USSN 10/042,237

Art Unit 2644

Amendments to the Drawings

App No. 10/092,231;
Att. Unit: 2684**FIG. 3**

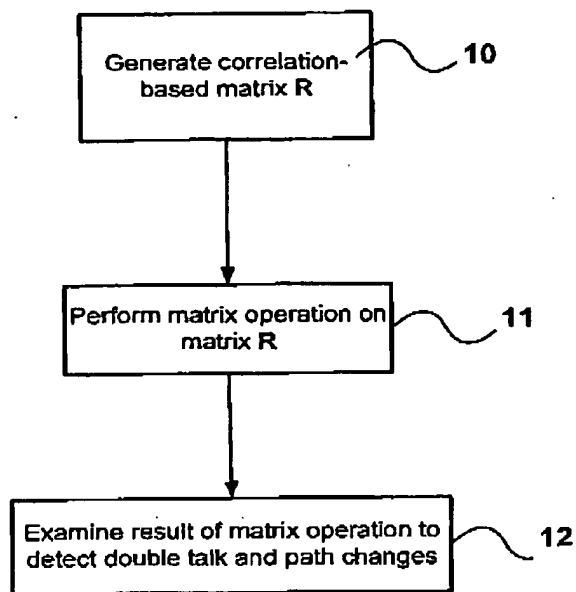
Permission is respectfully requested to replace the sheet of drawings containing Figure 3 on file with the replacement sheet submitted herewith. The newly added subject matter has been deleted in box 12 and replaced by wording taken from the specification.
